Service Note		
Products	Description:	Service note no.
Voicelive 3 and Voicelive 3 Extreme	Improvement of boot up reliability and stability during operation	SNo-T214

X2 is located here

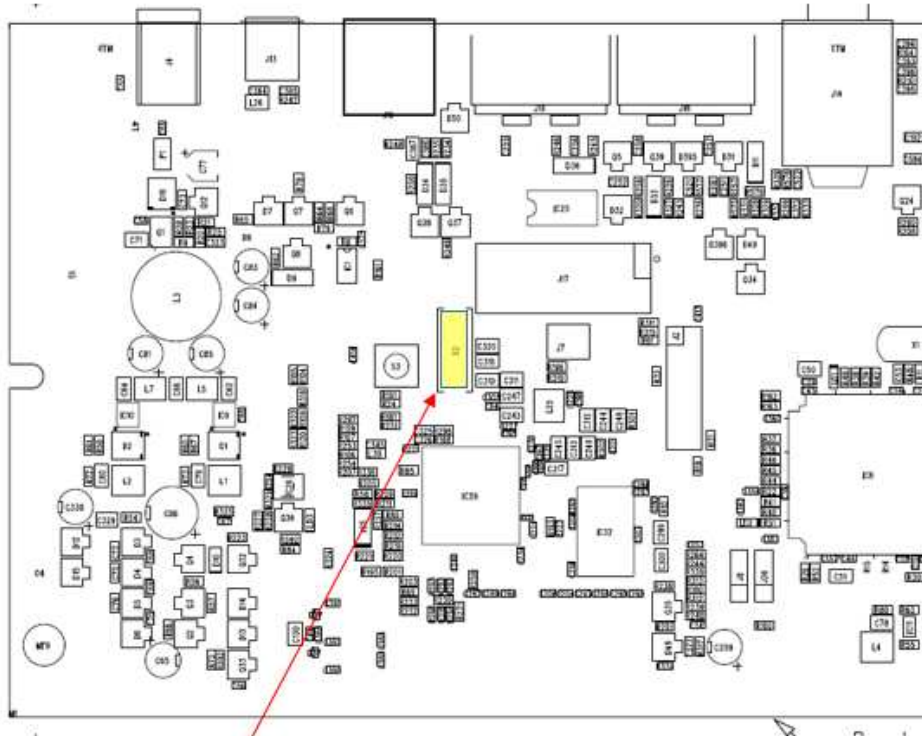
We have experienced a big manufacturing spread in the Abracon crystal, which some times have made the main oscillator network unreliable. This can cause boot up problems and poor stability during operation like for instance blue screen (freeze).

- X2 to be replaced with new ECS type (ECS-240-12-5PX-TR)
- C260 and C261 to be replaced with new 10 pF COG types
